**TOWN OF LOS GATOS
PLANNING COMMISSION AGENDA
OCTOBER 09, 2019
110 EAST MAIN STREET
LOS GATOS, CA**

**TOWN OF LOS GATOS
PLANNING COMMISSION AGENDA
OCTOBER 09, 2019
7:00 PM**

SUBJECT: Architecture and Site Application S-18-050. Project Location: **56 Central Avenue**. Property Owner: Andrew and Ashley Bothman. Applicant: Rick Hartman, HOMETEC Architecture. Appellant: Leslie Morley. Project Planner: Jocelyn Shoopman.

2 PROPOSED FIRST FLOOR PLAN
Scale: 1/16"=1'-0"
June 21st 12:00pm
December 21st 12:00pm

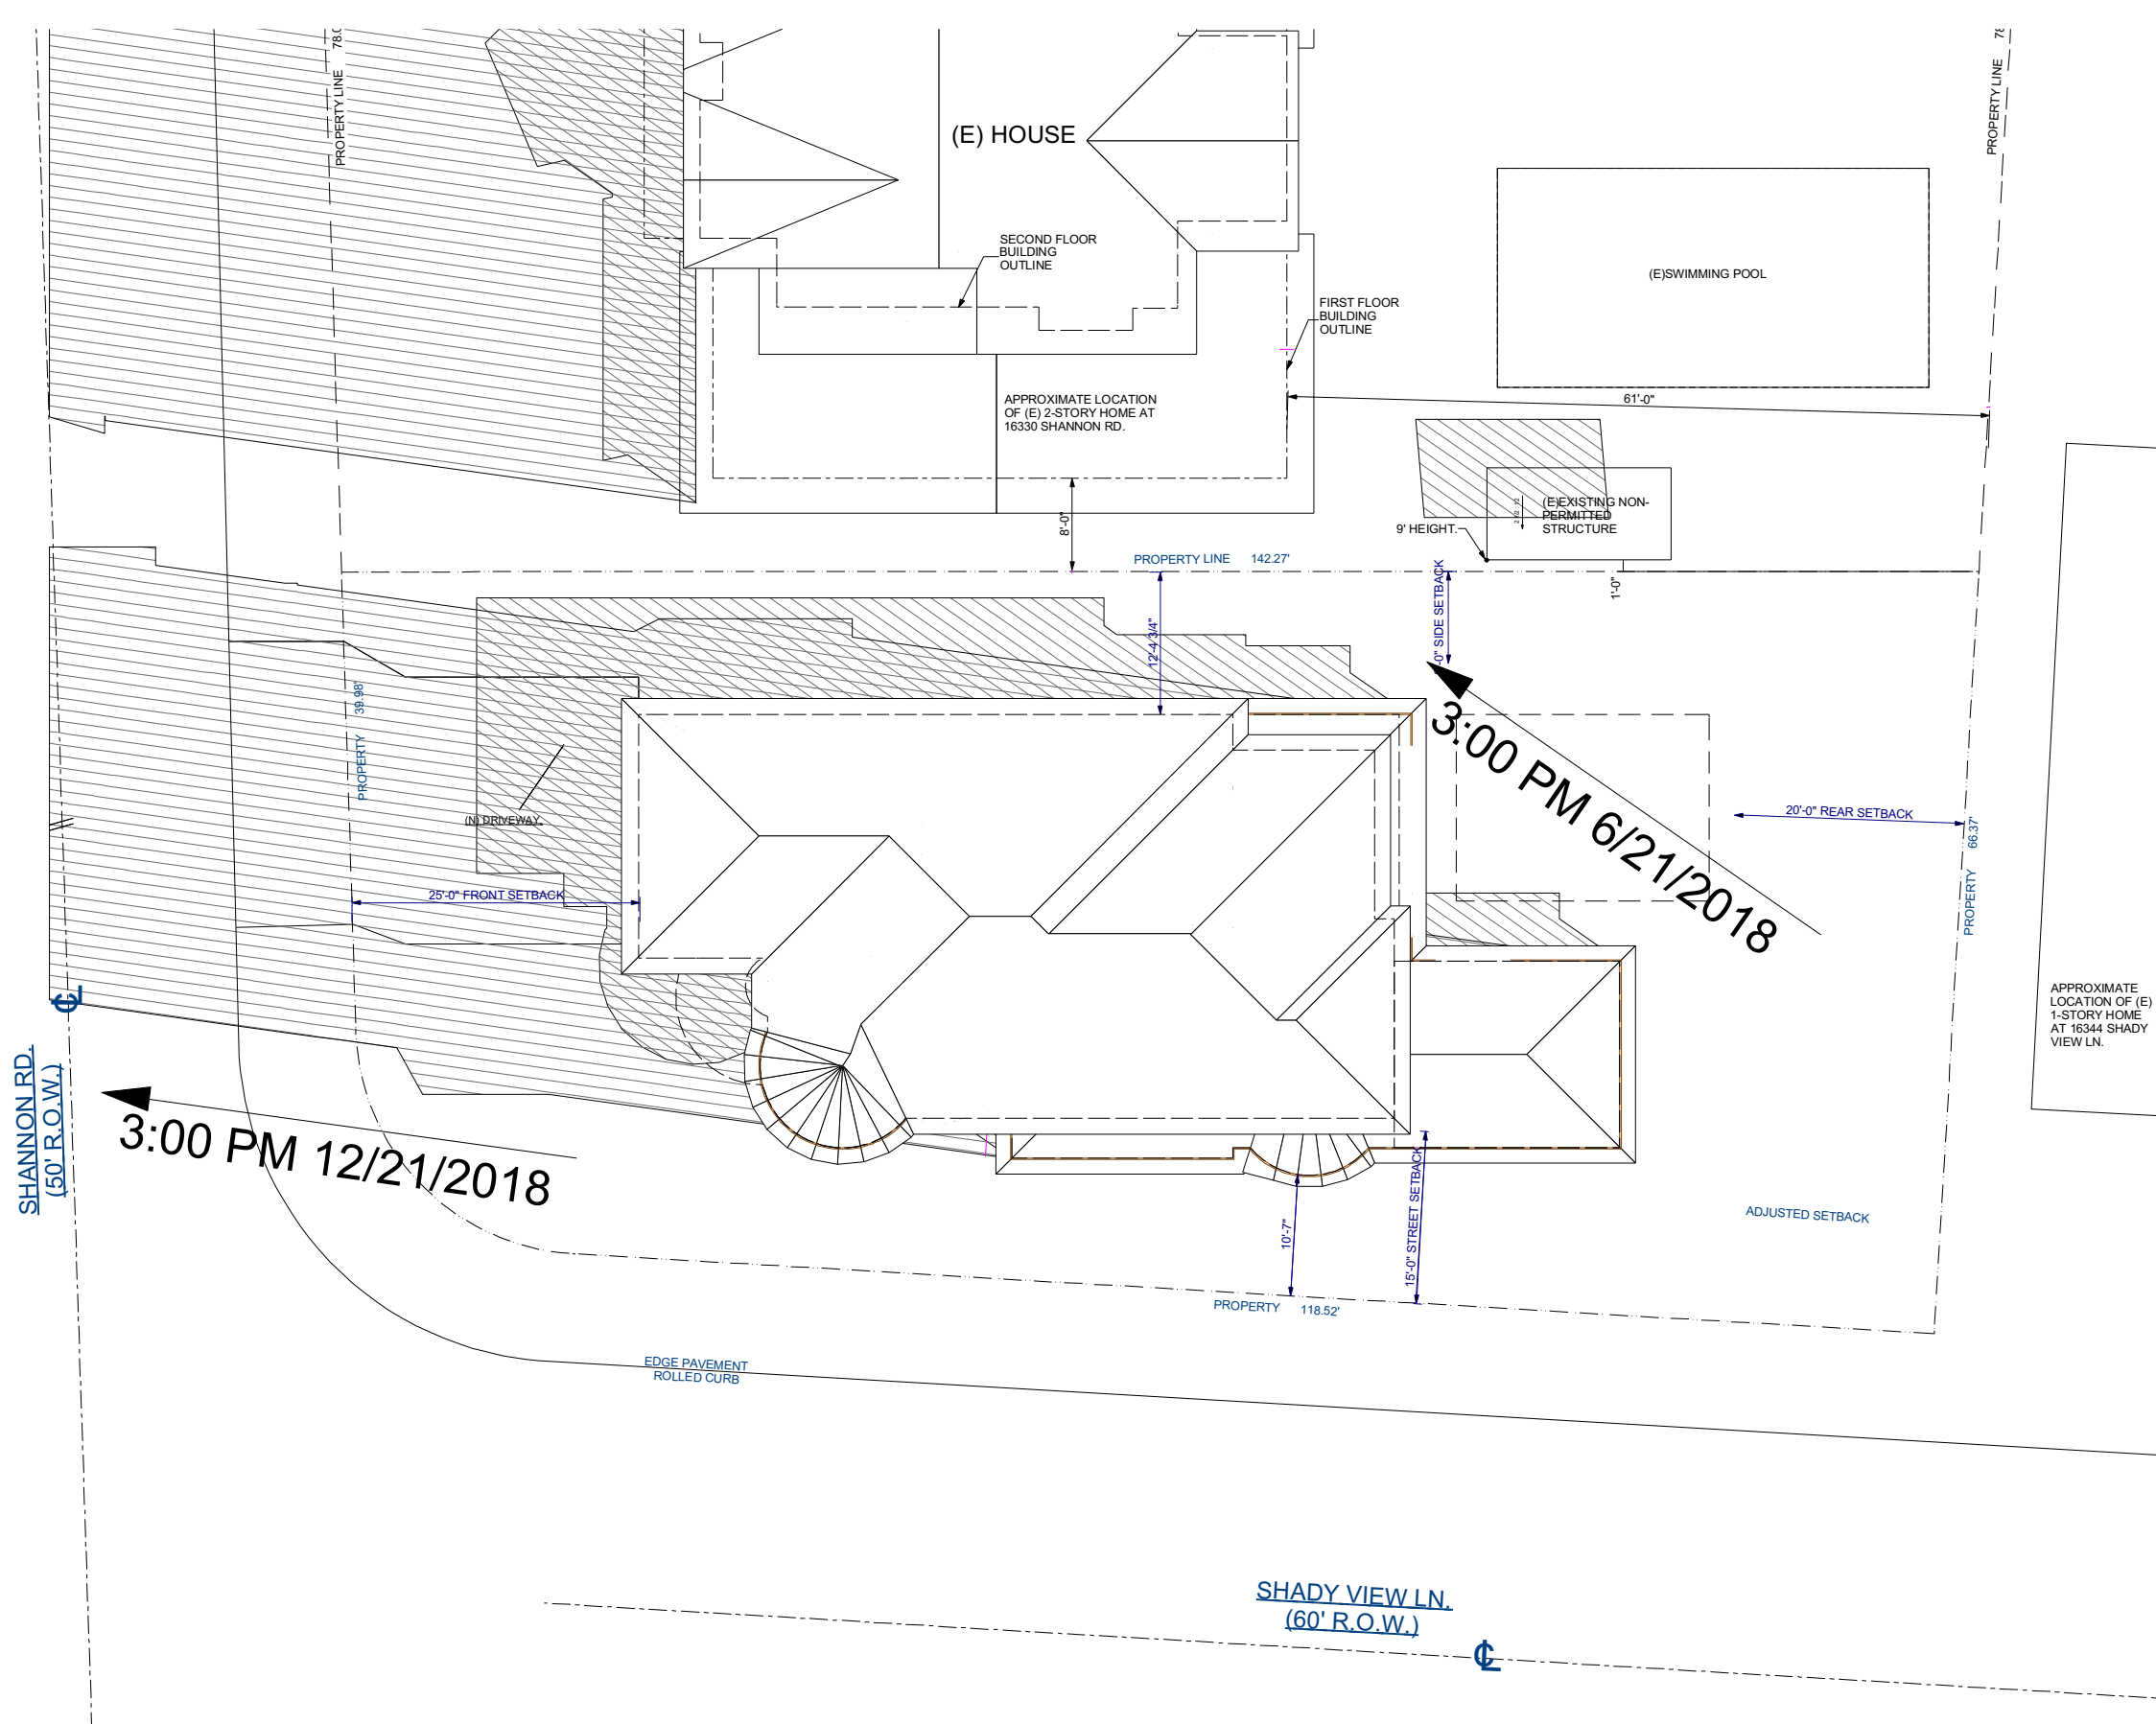
My review letter for this project identified a concern that the project's proposed second floor eave height would be substantially higher than that of the adjacent home at 16330 Shannon Road. I later received a revised drawing sheet A6.3, noted as "*Planning Set 7/9/2019*", which showed the adjacent home's height corrected to its actual height which is 29 feet - over three and a half feet taller than shown on the previous drawing used for the review. That review letter comment is therefore no longer applicable since the maximum roof height for new proposed new home at 16336 Shady View Lane height is 28'-7" which is is comparable to the adjacent existing home.
